Impact of TDECQ CER Settings on Measurement Consistency

Associated with comments 51 and 54 against IEEE 802.3dj D2.3

Roberto Rodes, Coherent

CER TDECQ Test Variability vs. SPUI (Same Tx)

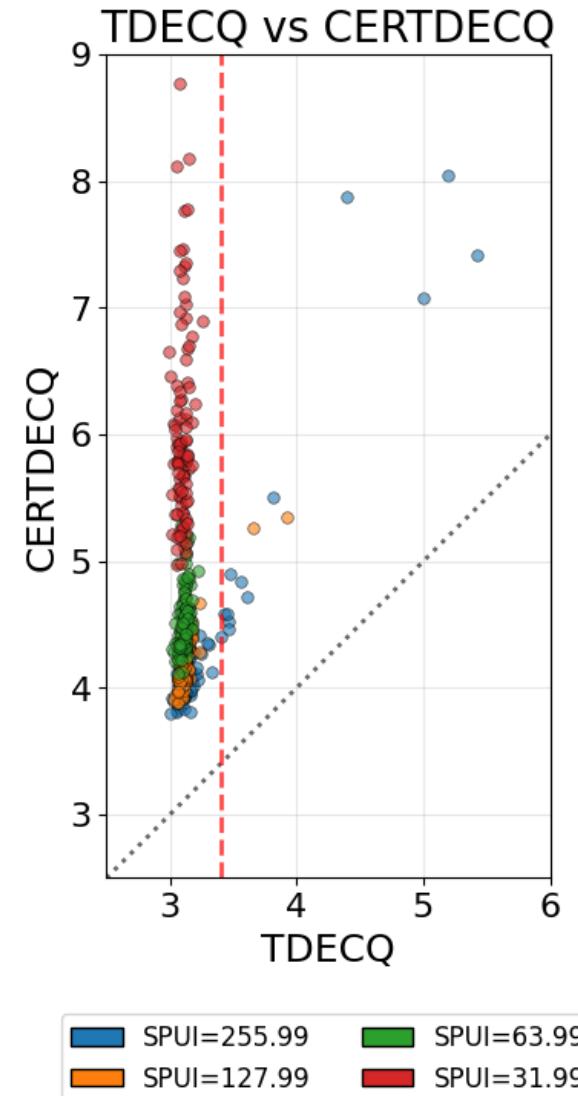
- One 200 Gb/s lane
- 400 consecutive re-tests of TDECQ and CER TDECQ
- Four samples-per-UI (SPUI) settings compliant with the current draft (>25 sa/UI)

- CER TDECQ distributions narrow as sa/UI increases.
- Test variability and error are strongly dependent on SPUI.
- SPUI values >127 show convergence issues and significantly increase test time.

Specify the test with a fixed SPUI value of **63.99** to reduce test variability.

Cl	180	SC	180.9.7.1	P486	L41	#	51
Rodes, Roberto				Coherent			
Comment Type	TR	Comment Status	D		TDECQCER (CO)		
				TDECQCER has significant variation, narrow histogram window and higher number of samples per UI improves the variability			
<i>SuggestedRemedy</i>				specify >63 sample/UI and 0.02 UI width histograms. Replace "The waveform should be acquired with greater than 25 samples/UI. This provides at least one sample falling within both the left and the right 0.04 UI width histograms for each symbol." with "The waveform should be acquired with greater than 63 samples/UI and 0.02 UI width histogram. This provides at least one sample falling within both the left and the right 0.02 UI width histograms for each symbol."

Effect of Histogram Width

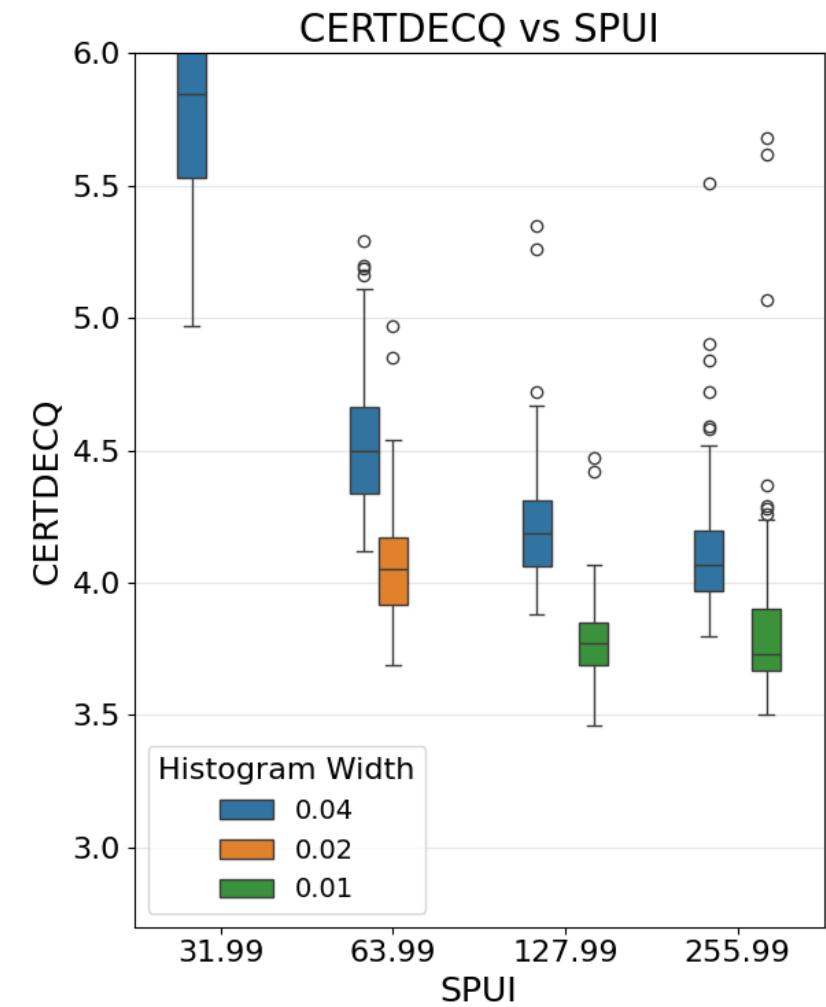
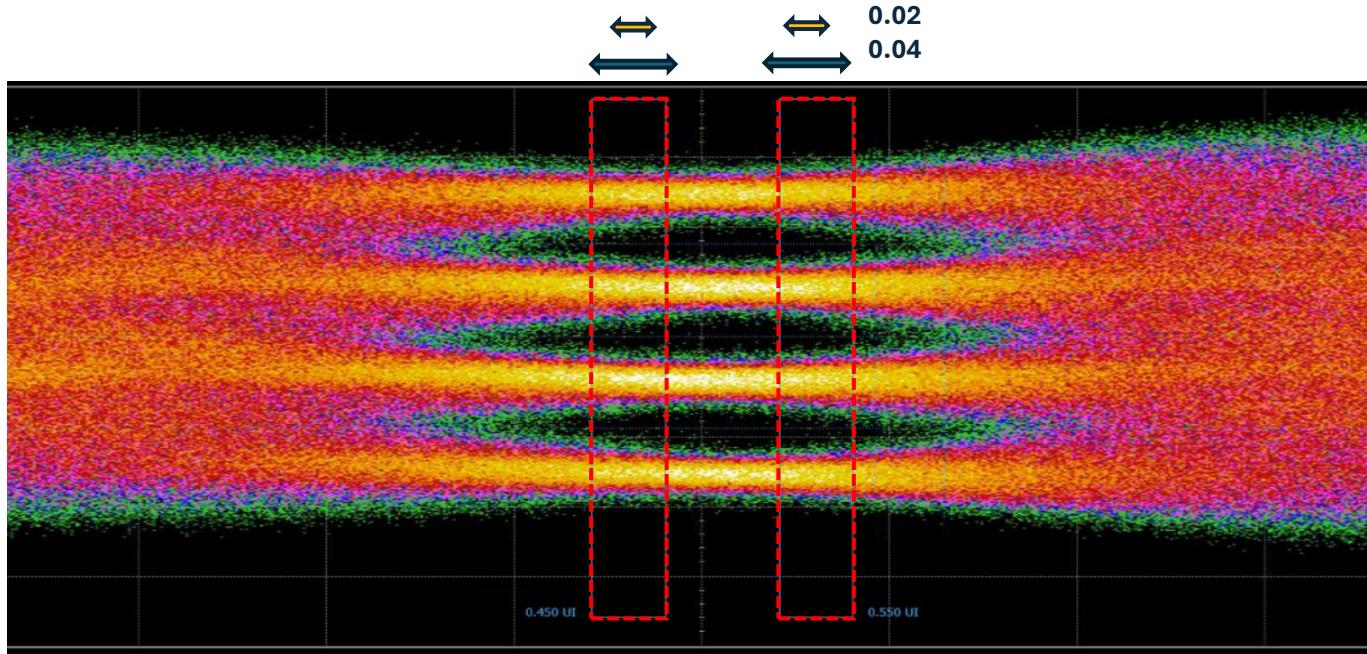
Higher sampling rates allow a narrower sampling window, reducing sampling variability while still ensuring at least one sample per symbol.

Reducing histogram width from **0.04 UI** to **0.02 UI** lowers CER TDECQ values and slightly reduces test variability.

CER TDECQ Excursion Relative to TDECQ

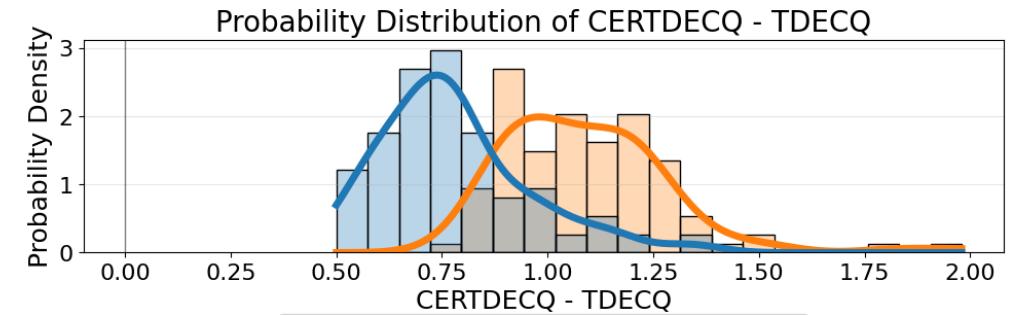
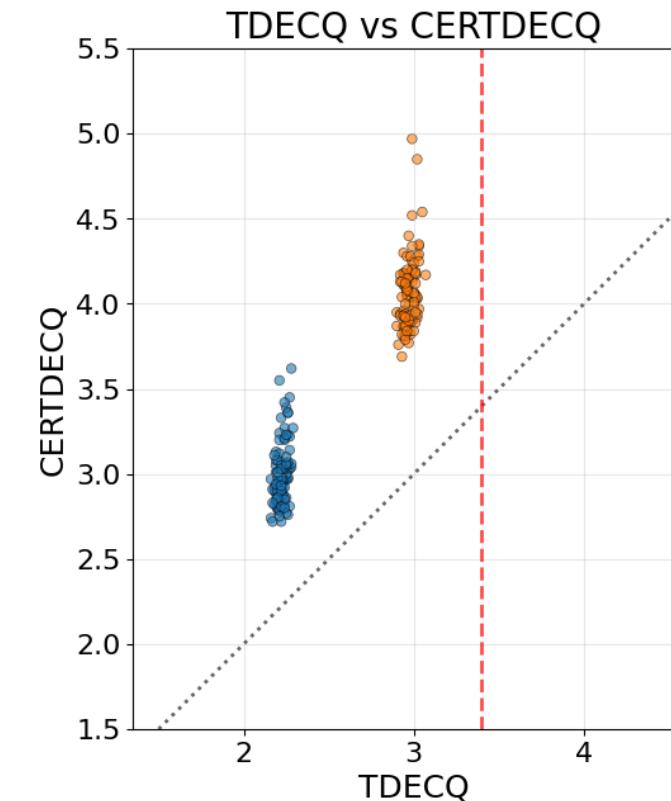
- Two different transmitters
- 100 consecutive re-tests of TDECQ and CER TDECQ
- SPUI = 63.99
- Histogram width = 0.02 UI

- Lower-TDECQ Tx: excursion from **0.5 to 1.3 dB**
- Higher-TDECQ Tx: excursion from **0.7 to 2.0 dB**
- Observed excursion exceeds the **1 dB margin** currently added in the draft.

Cl	180	SC	180.7.1	P470	L34	#	54
Rodes, Roberto				Coherent			
Comment Type	TR	Comment Status	D		TDECQCER (CO)		
				If TDECQCER better correlates with Rx Sensitivity, it should replace TDECQ for calculating link budget and OMA specs. However, TDECQCER does not combine samples of all 65k PAM4 symbols to create distribution but creates distributions for each PAM4 sample. This drastically reduces the number of samples available to create stable statistics.			
<i>SuggestedRemedy</i>				Oscilloscope testing is better suited for traditional TDECQ and new TDECQCER. Traditional TDECQ has shown good correlation for most cases.			
				Remove TDECQ CER from the spec. Do the same for CL 181, 182 and 183

Why Test Variability Is a Concern

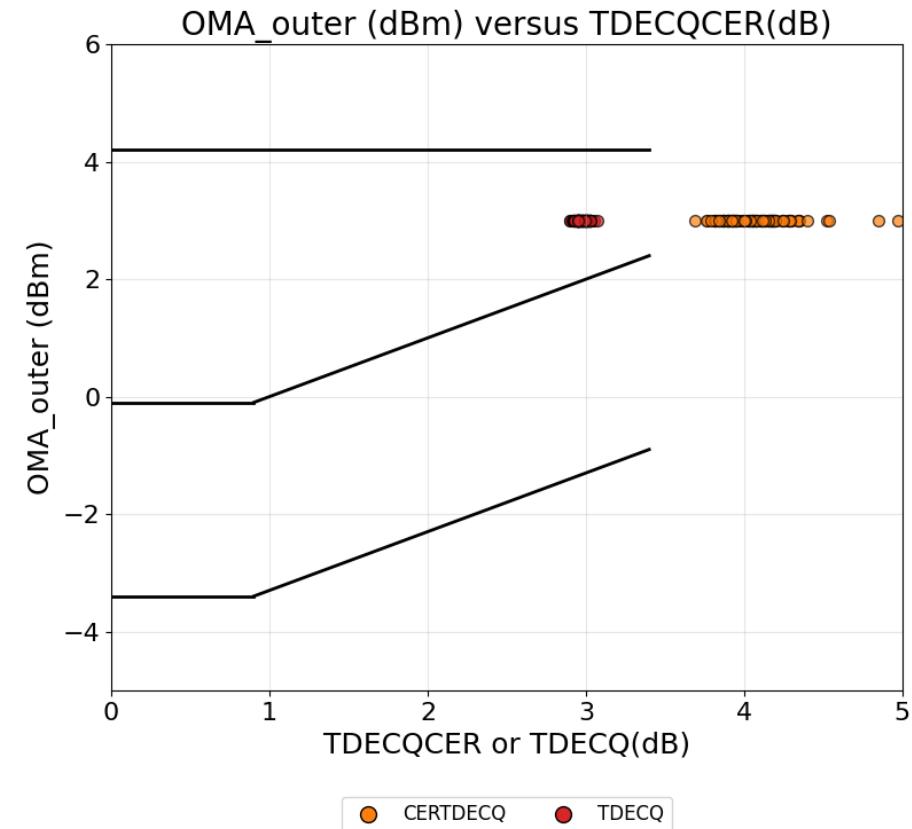
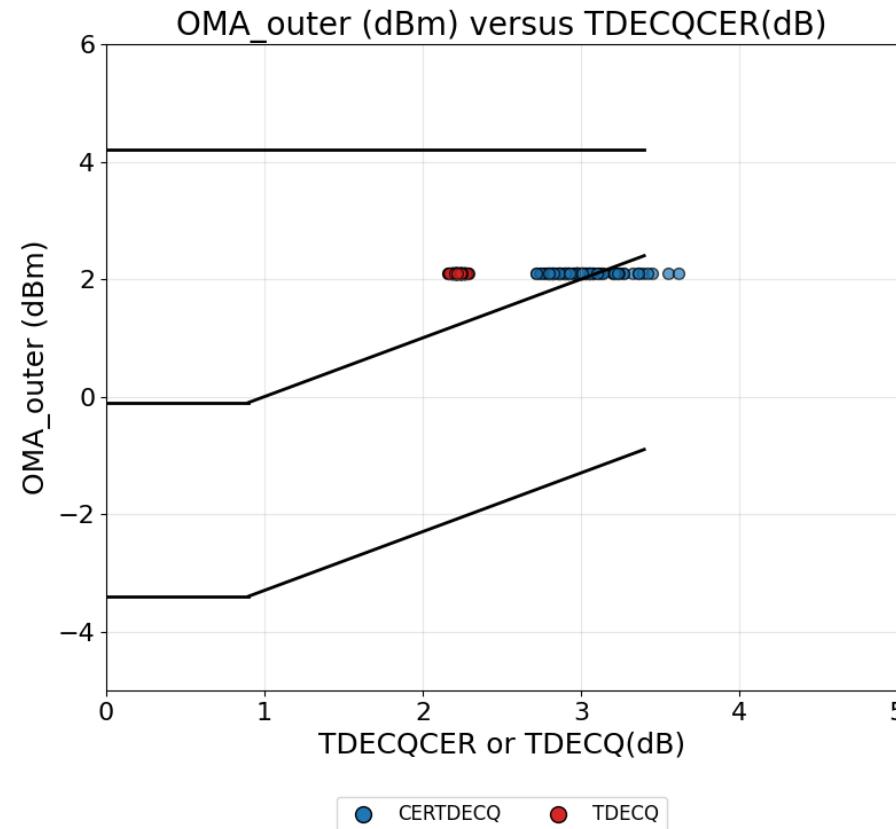
- CER TDECQ is intended as an enhanced TDECQ with improved correlation to BLER performance penalty.
- However, the current level of CER TDECQ test variability would make Tx OMA allocation for link budgeting extremely challenging.

TDECQ vs. CER TDECQ

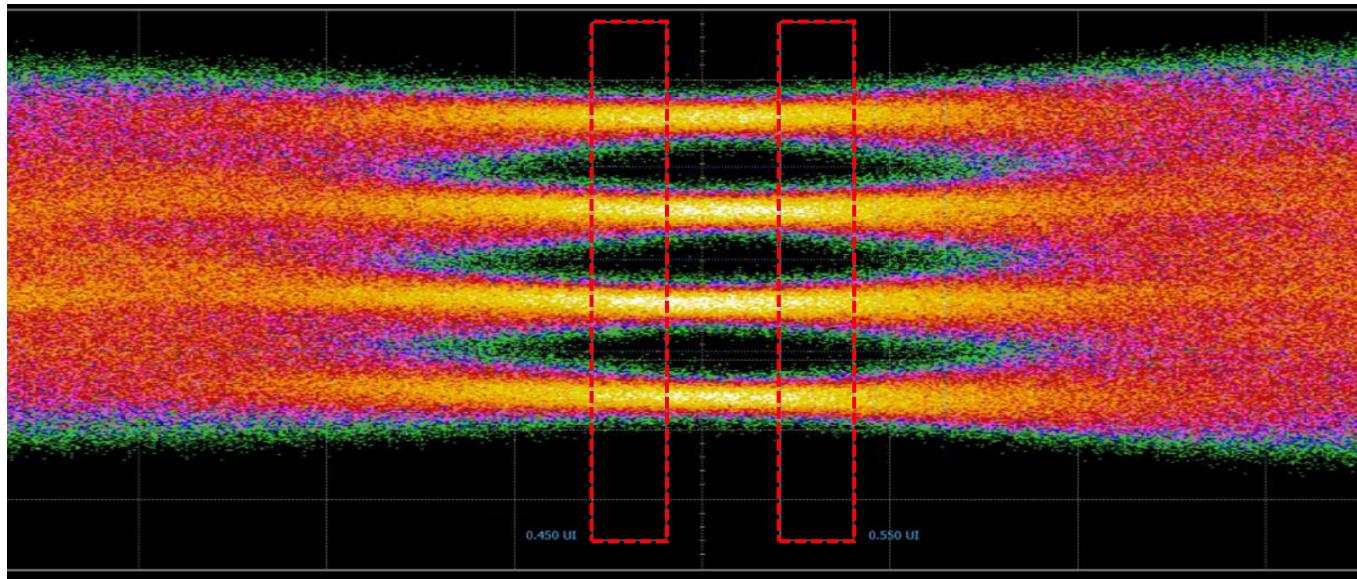
TDECQ builds a single distribution from samples across all symbols of the entire SSPRQ pattern, making it a consistent distribution that is largely insensitive to the scope random sampling phase and noise of a particular measurement instance.

CER TDECQ forms 65,535 per-symbol distributions, often with as little as one data point, making them more sensitive to random scope sampling phase and noise of a particular measurement instance
